Ref. No.: HUS-CPB-NA-LTR-00025

Re Completeness Review of Husky Tie-Back Project Development Plan Documents

DPA Comparison With No Gas Lift

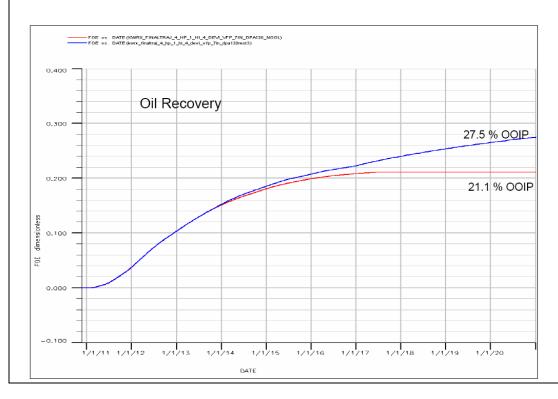
A discussion of artificial lift requirements is required.

"Gas lift is planned for use in the North Amethyst field similar to the development of the South Avalon production wells. The following plots present the North Amethyst production profile and recovery factor with and without gas lift. Note that the red curves relate to the no gas lift case and dashed lines are typical cumulatives for the one 120,000 bbl/d deterministic case.

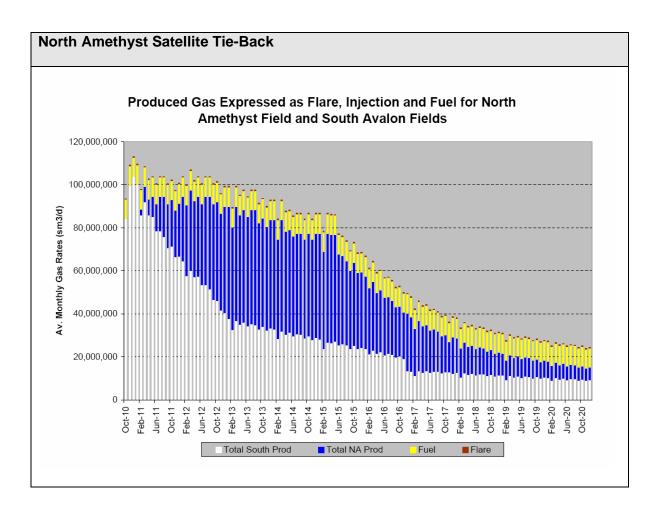
Gas Conservation Methods – What will be the amount of produced gas expressed as flare, injection and fuel? This should be provided from the North Amethyst field as well as the total project. This should be provided in tabular and graphic format.

"The following figure and associated table is based upon the proposed combined North Amethyst and South Avalon Base Case Production Profile which shows North Amethyst tied back in 2010.

This base case North Amethyst simulation model was run together with South Avalon production and assumes an annualized production rate of 120,000 bopd (barrels of oil per calendar day). The assumptions used in conducting the base case North Amethyst simulation model are detailed in Section 3.3.2. It should also be noted that any change to these assumptions will impact the results presented in this section.
